1. DETAILS OF THE DEVELOPMENT

Ref: 21/01997/PRE
Location: Citiscape, Drummond Road and Frith Road, Croydon, CR0 1TW
Ward: Fairfield
Description: Demolition of existing buildings; redevelopment of the site to deliver approximately 130 new homes across two residential buildings, landscaping, car parking and associated works.
Applicant: Barratt London
Agent: Quod
Case Officer: Neil McClellan

- 5.1 An earlier iteration of the current designs were presented to the Council's Place Review Panel on 16 September 2021, see images and plans below.

Images 10 and 11: Ground floor plan and Drummond Road frontage visualisation

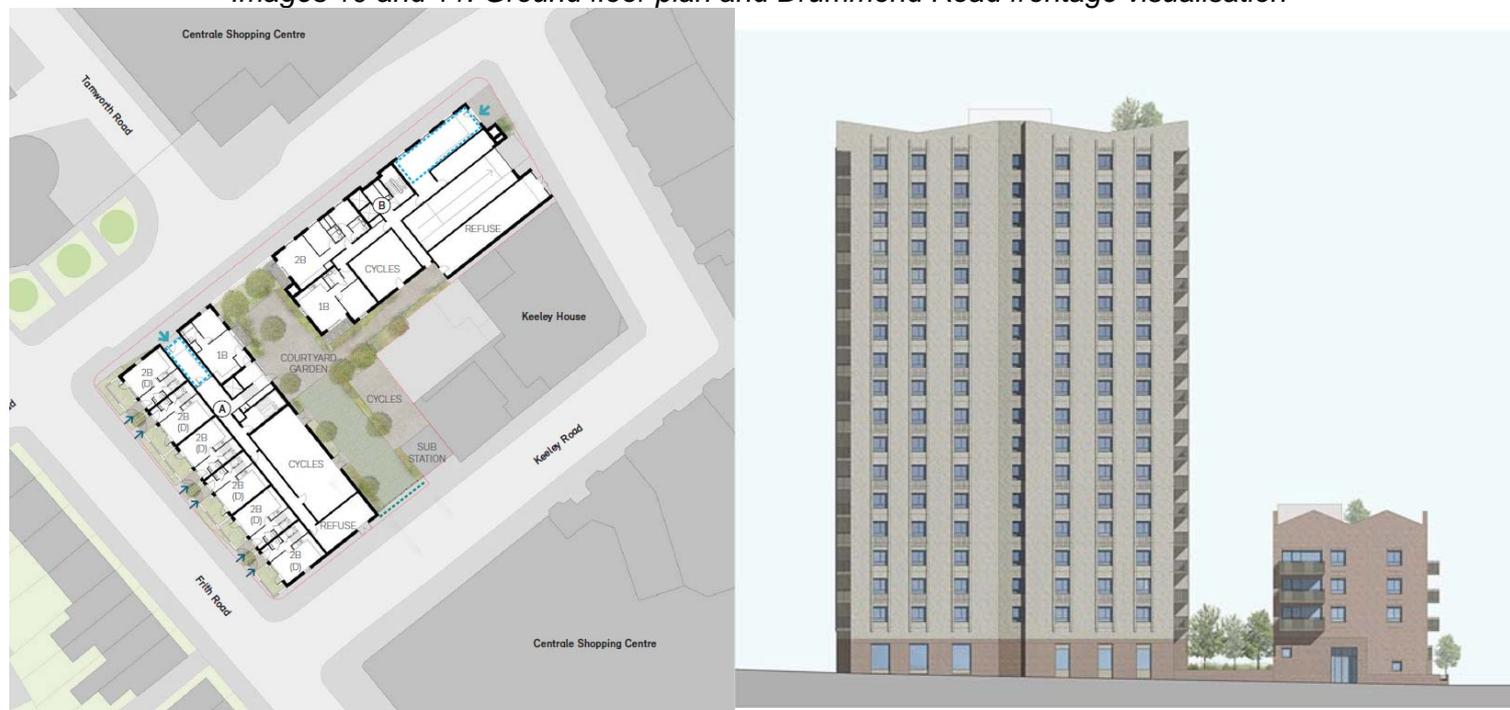
- 5.2 The Panel were broadly comfortable with the approach to Frith Road and its interface with the Church Street Conservation Area. The Panel recommended developing the street level visualizations in more detail noting it is not just long range views which are important, but also the pedestrian experience of an area. The detailing and quality of the scheme will be critical to enhance the setting of the Conservation Area. The Panel expressed some concern over the taller element in certain views. The most sensitive view is from the Grade I Listed Minster. The prominence of the tower as an ecclesiastical way marker must be retained. Whilst the proposed development appears in the background of views of the Church, the Panel noted there is an existing consent which is taller and in closer proximity. The Panel need to see more detailed information to confirm that the taller element is acceptable. This could include additional views of the scheme showing texture and grain.

- 5.3 The Panel concluded that the approach to massing appears sensible and acceptable in general. The principle of a lower element addressing the Conservation Area, and a taller element which transitions into the town centre was accepted. The Panel suggested further consideration be given to the "Base" "Middle" and "Top" of the taller building and how this could improve its articulation and proportion. The Panel commented that the "Base" of the taller building appeared tentative and was not even a fully storey in parts and the proportions

need further work. The Panel agreed the principle of dividing the wider elevation of the tall building with a vertical 'gap', but they suggested this was not yet bold enough. The current shadow gap does not provide sufficient relief or depth, which may result in the facade appearing flat and dull. In terms of the roofscape, the Panel commented that this seemed to work successfully on the lower block, but further consideration is needed on the treatment of the "Top" of the taller block.

- 5.4 The Panel acknowledged that this is a difficult site with challenging adjacencies to both the Conservation Area and the large edifice of the shopping centre and car park. The Panel stressed that the open space is critical to the identity of the development and could be a big selling point for future occupiers if better laid out and with more specific spaces. They felt the location of the communal entrances to the blocks should be from the central courtyard which would activate the courtyard and encourage interaction between residents of different blocks. The Panel were concerned the current route to the amenity space would be circuitous and fear the courtyard would not be well used. The Panel accept the justification and rationale for the entrance on the Northern corner. However, they encouraged the applicant to see if there were other ways of creating visual connection through from the lobbies to the courtyard. The Panel strongly recommended introducing internal amenity space in place of the bike stores. This would bring a better outlook and use of the courtyard and be a benefit to the residents with children that only have small balconies. Cycle parking could then be relocated to the basement.

- 5.5 The Panel commented that it was difficult to know what the intent for the landscaping of the internal courtyard was, which they could only judge on the architecture around it. This suggested the space would have blank frontages, indirect routes and may be overshadowed for large parts of the day. The applicant was encouraged to further develop this aspect. The Panel noted that lots of children will live in the development and there needs to be a robust play space strategy. The Panel agreed that gating the green space is the correct approach, given the condition of surrounding roads and that safety and good lighting needs to be designed in. The Panel suggested that the design team look closer at the ground floor experience as a pedestrian and how this can be improved. The applicant should also consider place making interventions at key junctions such as at Drummond/Frith Road. There are also opportunities to have more active frontages along Drummond Road as this is a key route up to the High Street. Generally, the applicant should look at the quantum of green infrastructure provided and should aim to maximise biodiversity net gain and environmental net gain.

- 5.6 The Panel believe a dual aspect, gallery style arrangement for the southern block could work better than single aspect on to public streets. In further developing a "Base" "Middle" and "Top" strategy for the taller building, the applicant should consider how outlook changes as you move up the building. The lower level flats on Drummond Road would face directly onto the back of the shopping centre and car park, whereas upper level flats would likely have open views of the town

centre. The Panel believe the elevation treatments should change in response to the differing conditions and orientation. At present they are bland and non-descript. Detailed floor plans were not provided but the Panel stressed that all units and floor areas need to comply with the Mayoral Standards. Whilst it is positive that 13 disabled flats are provided, none of these are at ground floor level which should be reviewed.

Image 19: Pavement widening along Drummond Road, existing (l), proposed (r)

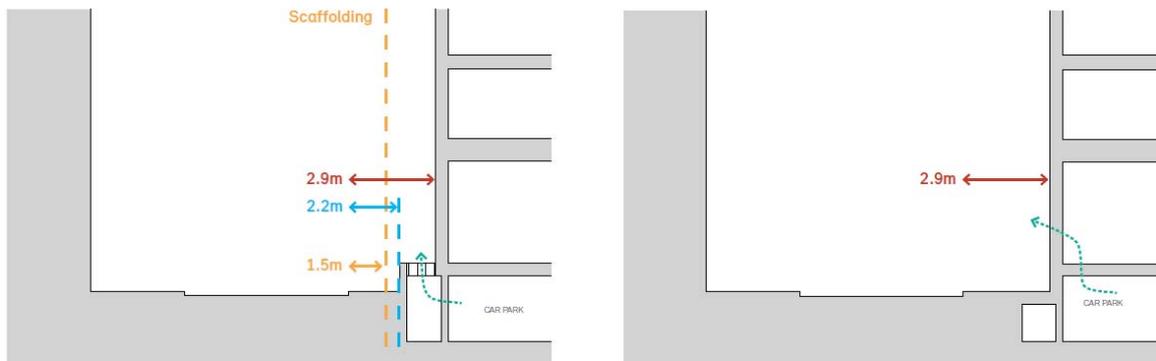
6.13 The massing and layout of the proposal allows for greater activation of the development's various ground floor frontages creating a much better relationship with the street and improving the public realm around the site. This is welcomed, particularly so along Drummond Road which currently suffers from blank and inactive frontages along both sides of the street and which is one of the main pedestrian routes into the Town Centre. The removal of the existing basement plinth and ventilation ducts (discussed above) also allows for the pavement along this side of Drummond Road to be widened creating a more generous and, with the other improvements discussed above, attractive public realm. This is fully supported by the Old Town Masterplan which seeks enhancement to public realm, active frontages and greening to Drummond Road.
